**Agenda**  
**Hailey Planning and Zoning Commission**  
**Monday, November 17, 2025**  
**5:30 p.m.**

## FINDINGS OF FACT, CONCLUSIONS OF LAW AND DECISION

On October 31, 2025, AT&T Mobility Corporation submitted a request to modify the existing Wireless Permit to upgrade the existing tower. The proposed modifications will occur inside the equipment room and to the existing tower on the roof. The Applicant is proposing the following modification to be permitted as part of the Wireless Permit Application:

Project 019420240354	Sheet <b>S-4</b>
Date 06/27/2024	
Drawn By: BU	Checked By: SC

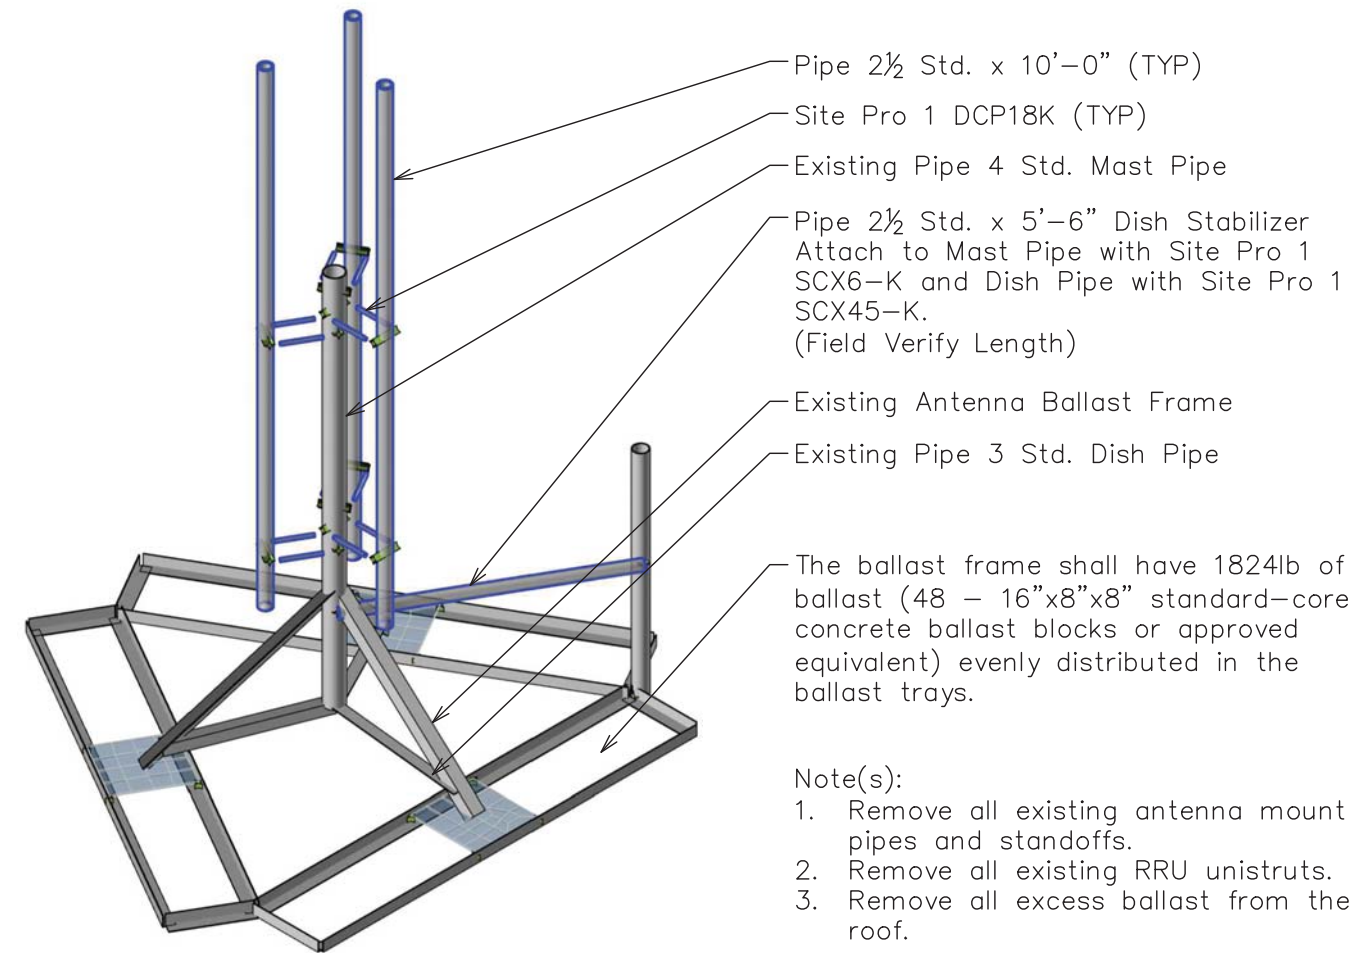
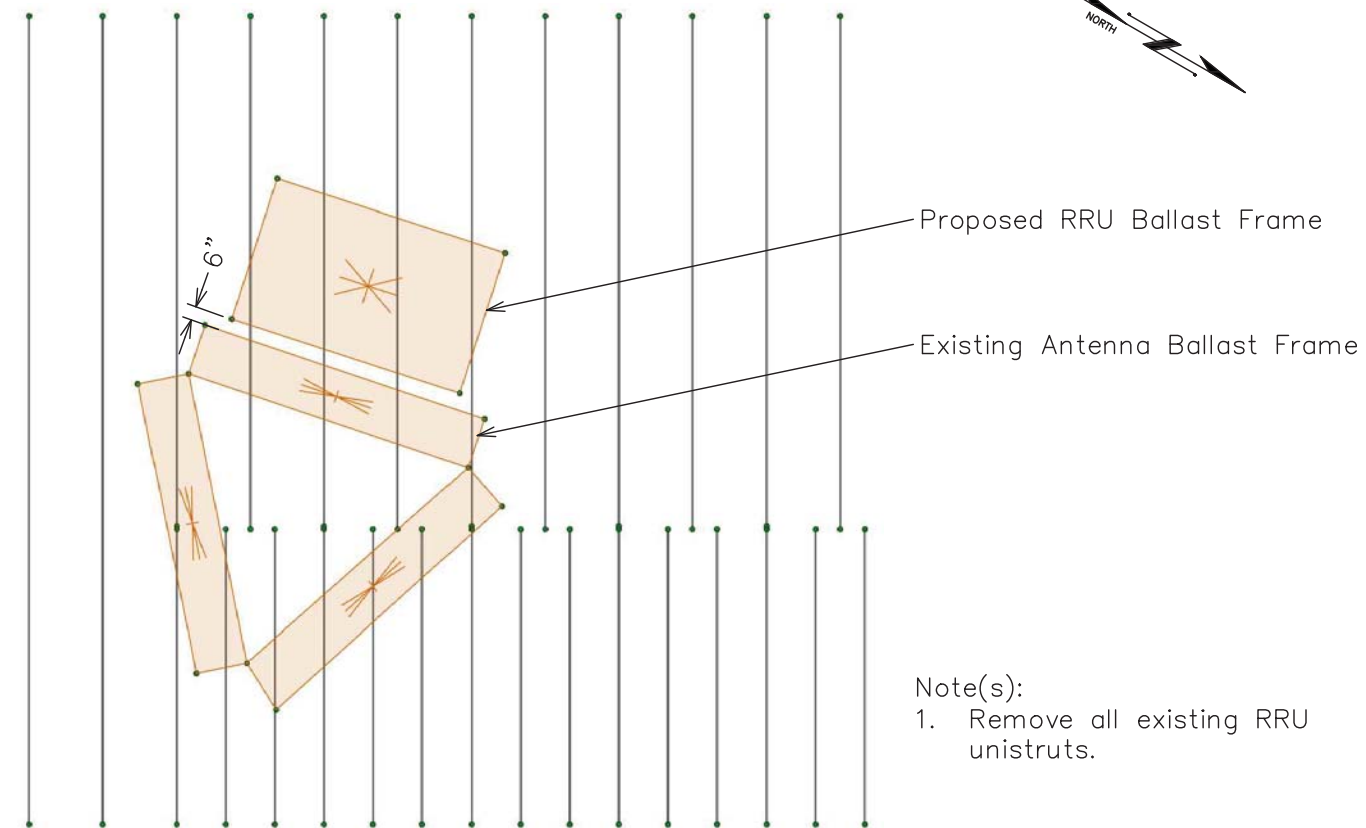
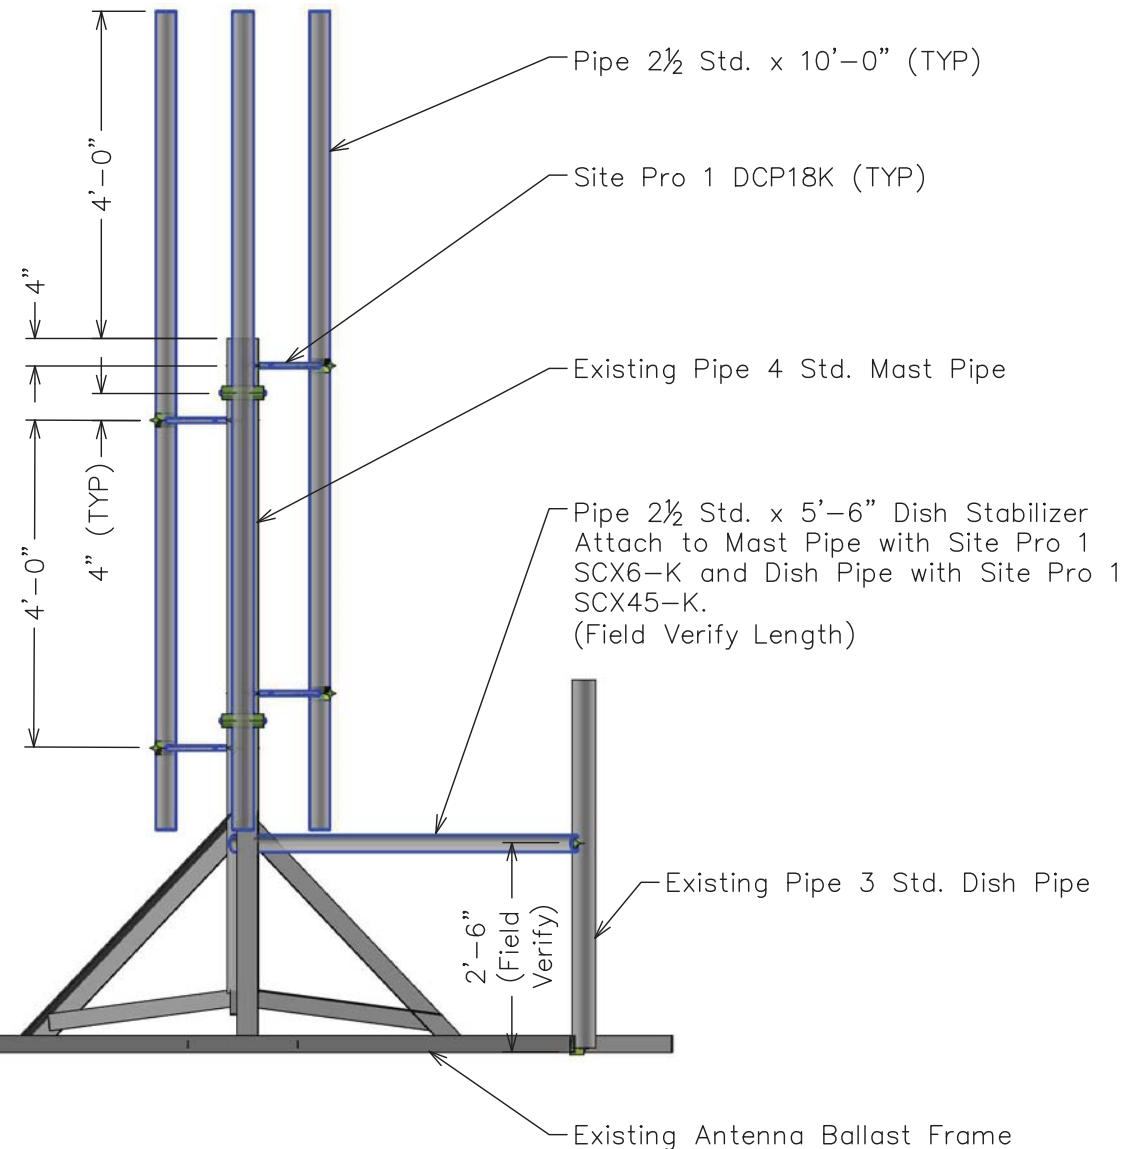
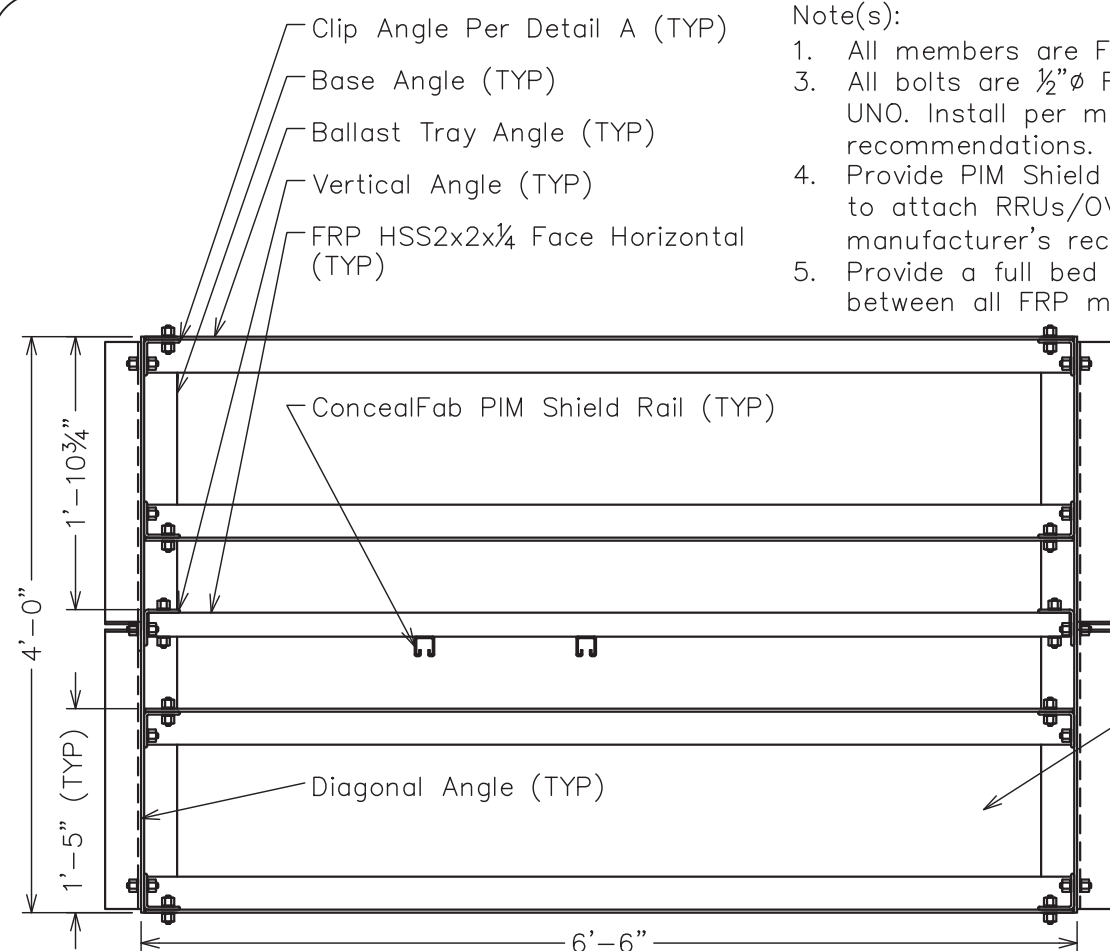
- 1) **The antenna ballast frame shall have 1824lb of ballast (48 – 16"x8"x8" standard core concrete ballast blocks or approved equivalent) evenly distributed in the ballast trays per modification drawings detailed in Appendix C.**

- 2) **Remove the existing RRU frame and replace with the proposed RRU frame per modification drawings detailed in Appendix C.**
- 3) **Remove the existing mount pipes and pipe-to-pipe connections and replace with Pipe 2½ Std. x 10'-0" pipes and SitePro1 DCP18K per modification drawings detailed in Appendix C.**
- 4) **The project Narrative, dated October 30, 2025, shall include the Analysis results from the Structural Analysis report under "Please note" to include:**
  - **Existing Antenna Frame Stress Level with Existing + Proposed Equipment: 68.5%\*CONDITIONAL PASS**
  - **Proposed RRU Frame Stress Level with Existing + Proposed Equipment: 78.2%\*CONDITIONAL PASS**
  - **Existing Roof Top Stress Level with Existing + Proposed Equipment: 93.2% PASS**

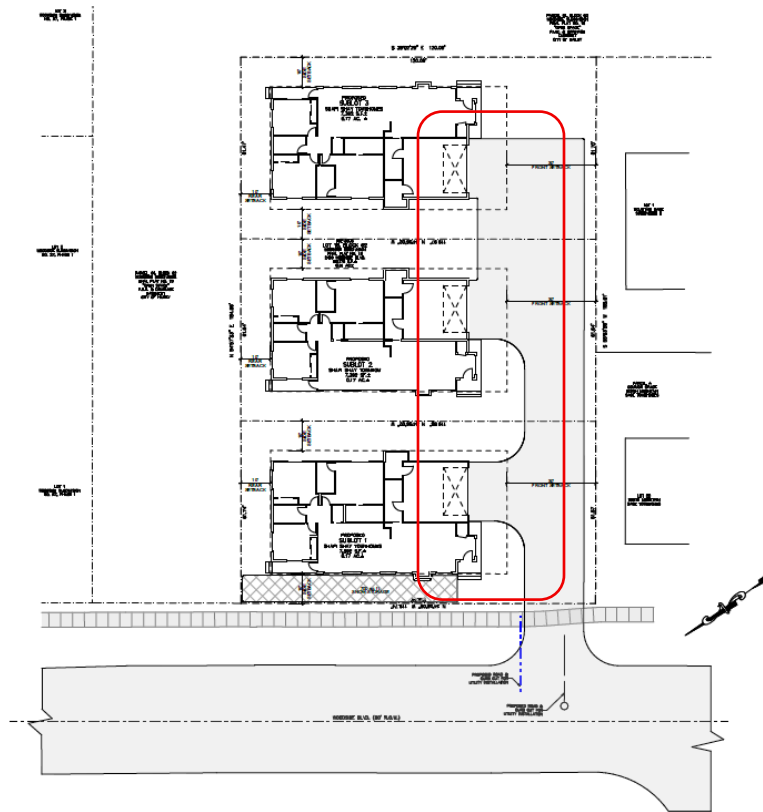
- While the landscape plan is still underway, Staff recommend that street trees be planted along Woodside Boulevard and within the public right-of-way. The Hailey Tree Committee will review said plan at a later date, and prior to the full Design Review hearing.

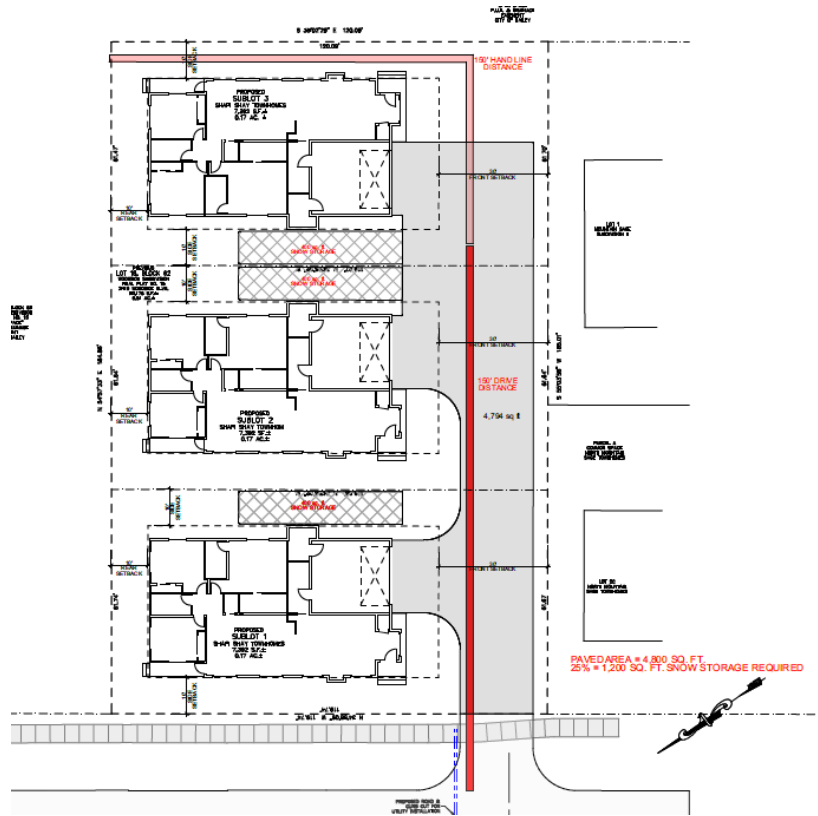
**Fire Access Lane:** As shown below, the proposed fire access lane (in red) has been approved by the Fire Chief.
